The Commission has issued the enclosed Amendment No. 9 to Facility Operating License No. DPR-69 for Unit No. 2 of the Calvert Cliffs Nuclear Power Plant. The amendment is in response to your application dated July 13, 1977, and supplements thereto dated September 30, 1977 and October 5, 1977.

CALVERT CLIFFS UNIT NO. 2

Amendment No. 9  
License No. DPR-69

ATTACHMENT TO LICENSE AMENDMENT NO. 9

FIGURE 3.2-4  
DNB Axial Flux Offset Control Limits

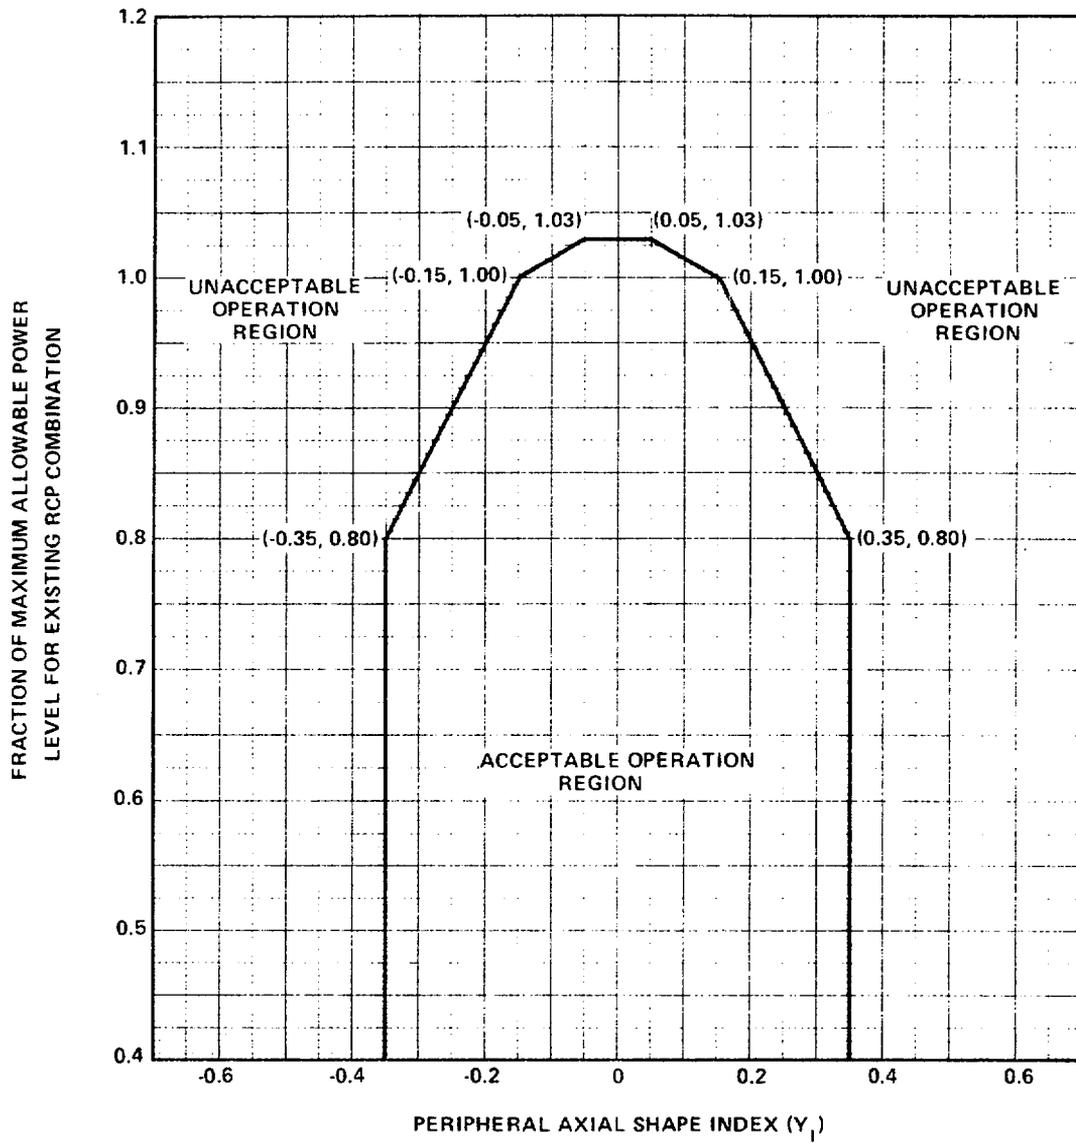
Section 3.2 (Figure 3.2-4) AXIAL FLUX OFFSET DNB OPERATING LIMITS modified for 2700 Mwt operation.
